Access Compliance Report

Public Rights-of-Way

(Curb Ramps)

Intersection ID: 12305	Main Street: E_5TH_ST	Cross Street: N_COLLEGE_ST	Location: SE
ADA ID: 73DE361EBCC3	Ramp Type: Perp	Initial Pass/Fail: Pass	Overall Compliance: No
		Severity Score: 5.25	
Codes/Mitigation Info/Possible Solution		Field Measurements/Component Compliance

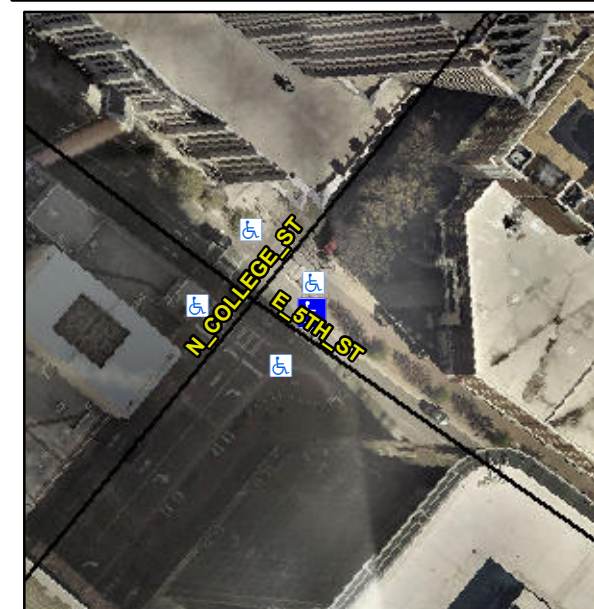
**Not Found, R304.5.3, R304.2.2-Perp,
R304.3.2-Para, R304.2.3**

Compliance	Description	Data	Compliance	Description	Data
N/A	Ramp Length (in)	34.0	Yes	Ramp Slope (%)	5.5
Yes	Ramp Width (in)	48.0	No	Ramp XSlope (%)	4.1
No	Flare Type	Curbed_WithWalkSurface	N/A	Flare Type RT	N/A
No	Flare Slope LT (%)	N/A	Yes	Flare Slope RT (%)	3.7
N/A	Flare Traversable LT?	No	N/A	Flare Traversable RT?	Yes
Yes	Landing Length (in)	48.0	Yes	DWS Provided?	Yes
Yes	Landing Width (in)	48.0	Yes	DWS Contrast?	Yes
No	Landing Slope (%)	3.6	Yes	DWS Length (in)	24.0
No	Landing X Slope (%)	3.9	Yes	DWS Full Width?	Yes
N/A	Landing Curb? (Y/N)	No	Yes	DWS Offset (in)	0.0
N/A	Shared Landing?	No			
Yes	Gutter Ponding?	No	Yes	Gutter Slope (%)	3.1
Yes	Gutter Lip Ht (in)	0.0	No	Gutter X Slope (%)	3.6
N/A	Painted X Walk1?	Yes	N/A	Painted X Walk2?	N/A
	X Walk 1 Direction	To SW		X Walk 2 Direction	N/A
N/A	X Walk 1 Width (in)	108.0	N/A	X Walk 2 Width (in)	N/A
	X Walk 1 Slope (%)	0.9		X Walk 2 Slope (%)	N/A
	X Walk 1 X Slope (%)	3.4		X Walk 2 X Slope (%)	N/A

**Remove & Replace Entire Ramp.
Remove & Replace Gutter.**
